Note:  
 These drawings cover both the 40m X and Y End Stations.  
 The cable numbers and device names shown are for the X end.  
 Y end cable numbers and device numbers should be substituted accordingly.  
 The Y end rack number is 1Y9.  
 The QPD is QPDY, the COS is ETMY, etc.

# This Page is Specific to 1X4

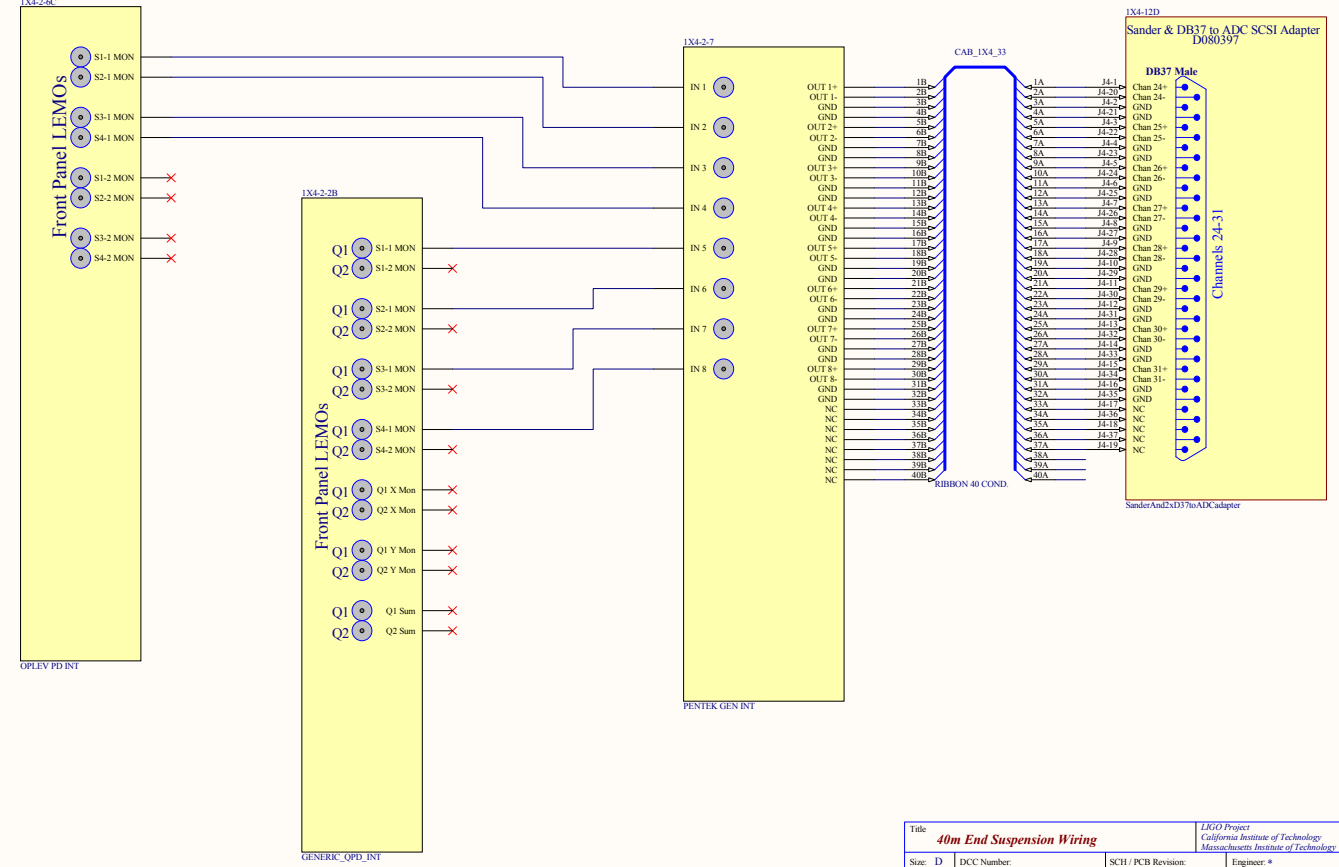
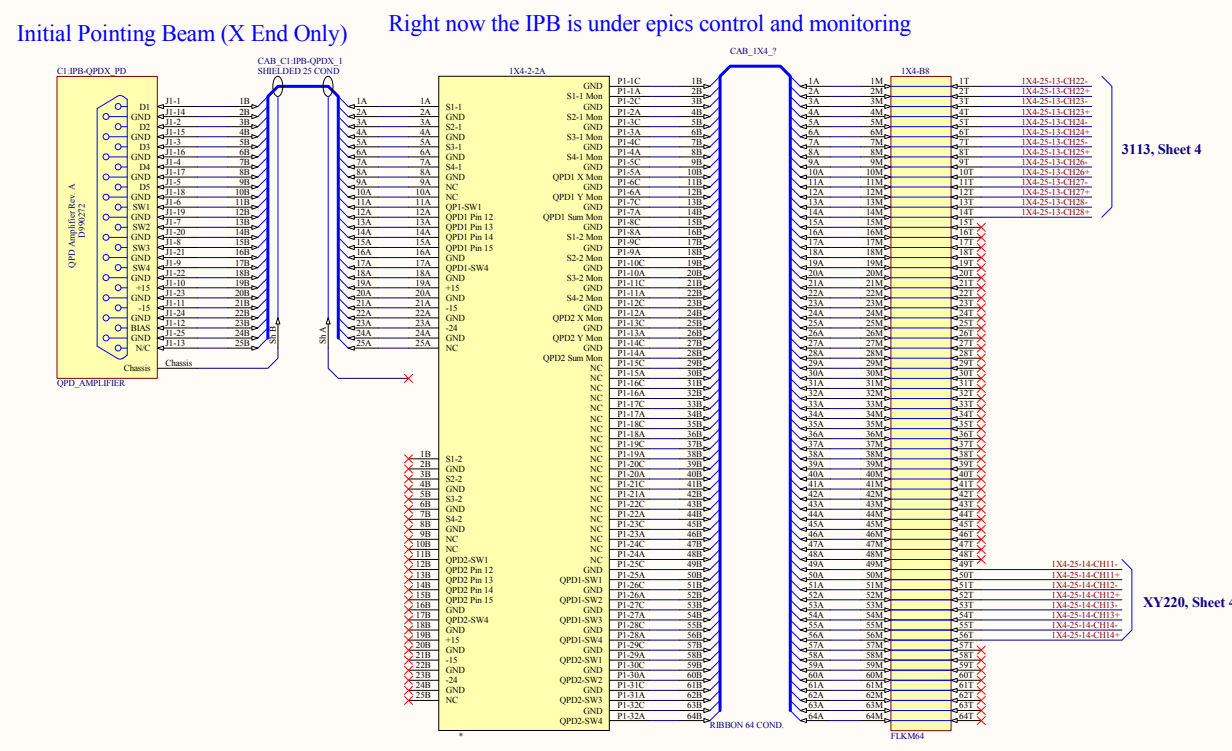
Rana thinks IPB should be hooked up as shown. Right now the coaxes go to the mon lemos of the ASC PD sheet 1. Those signals should go to fast channels.

ETMX

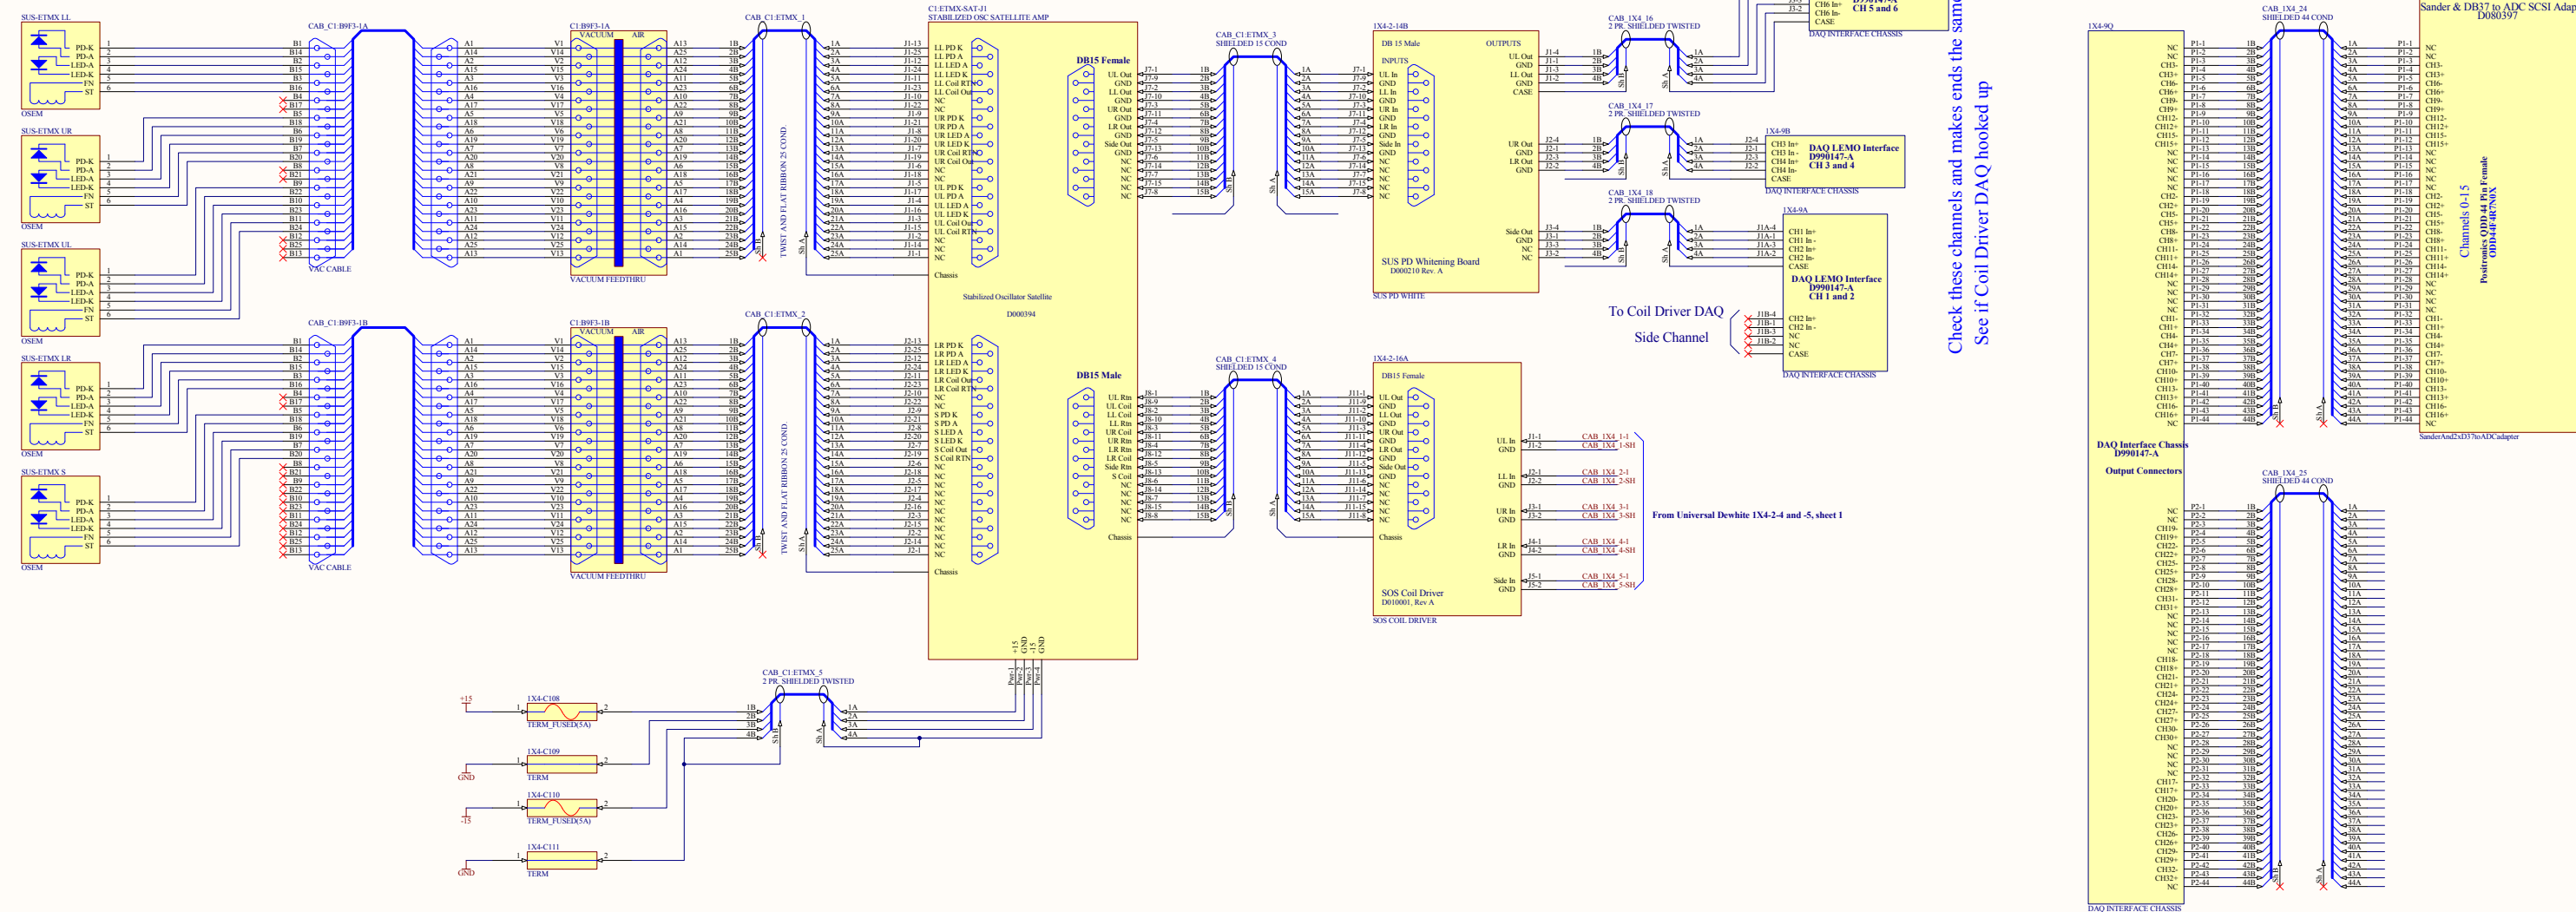
Check these channels and makes ends the same  
See if Coil Driver DAQ hooked up

**DAC 0 Channel Index**

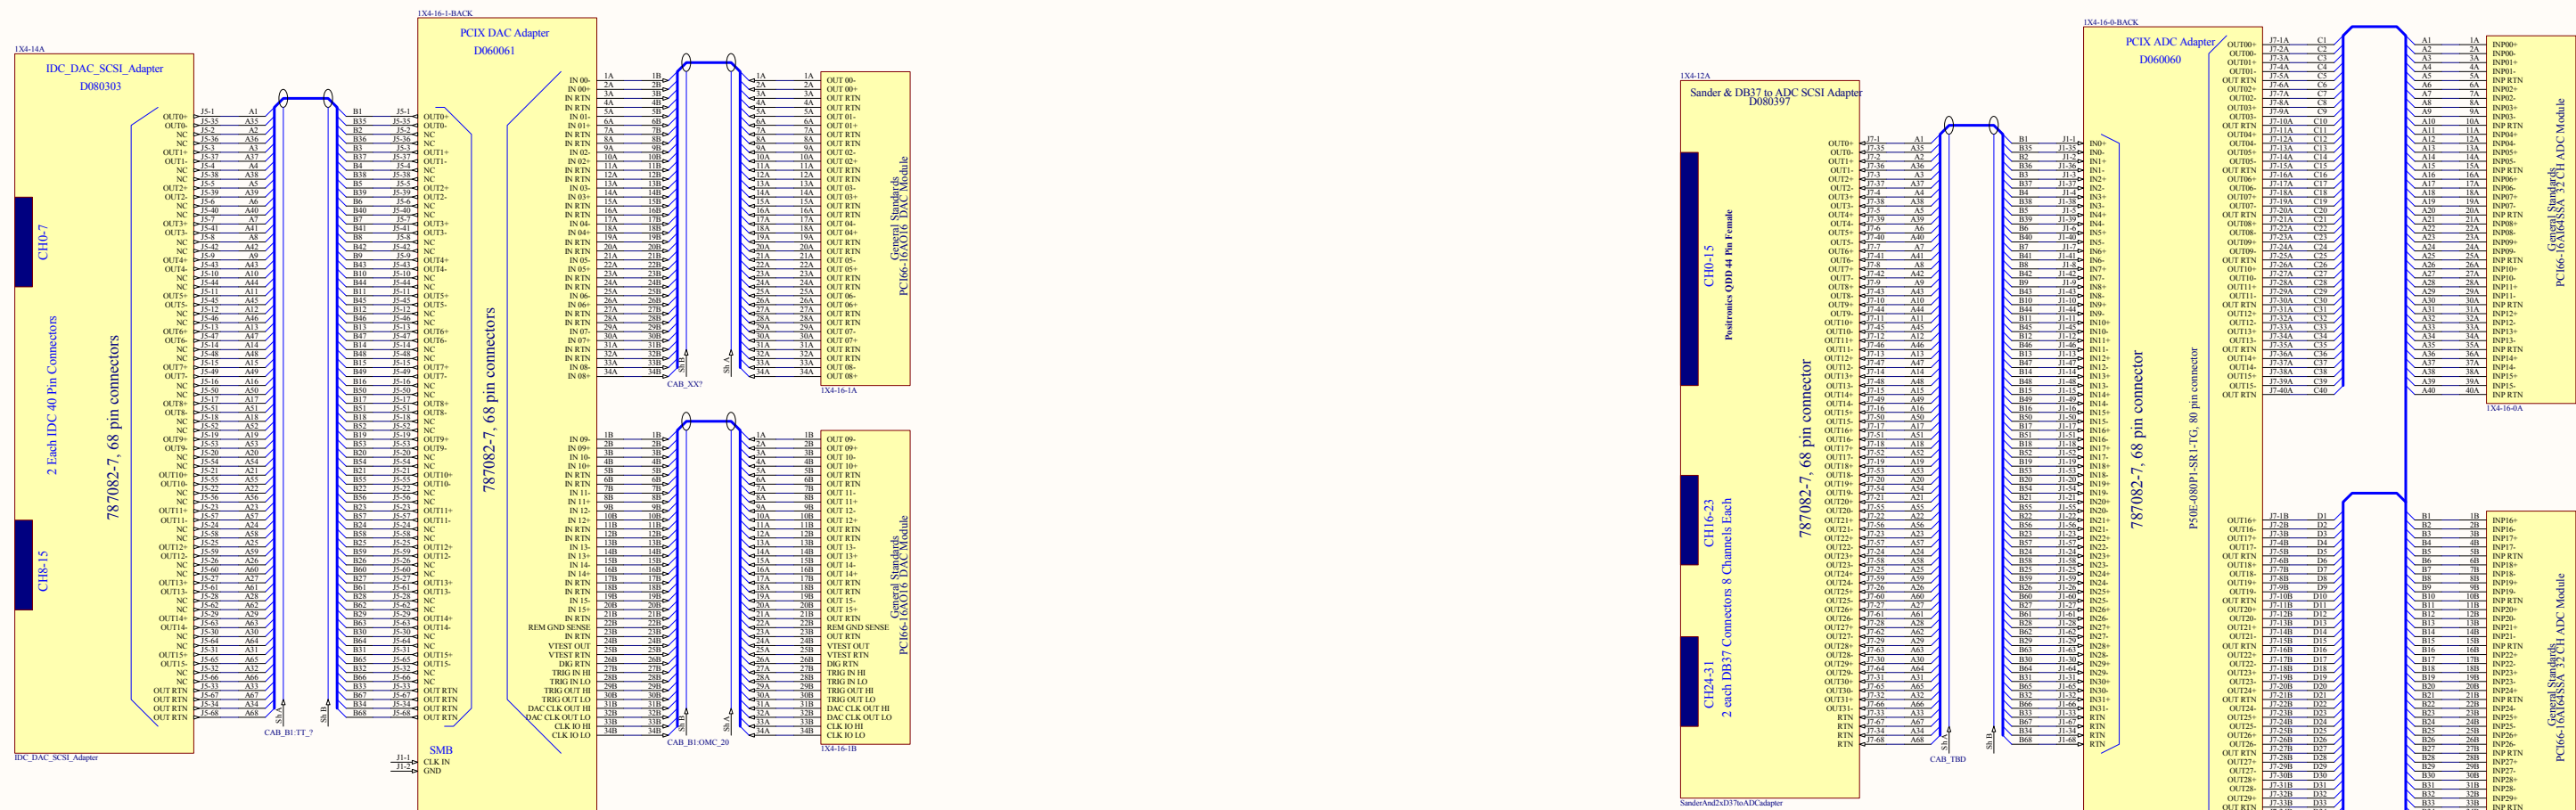
Coil Signals not connected. Should they be?
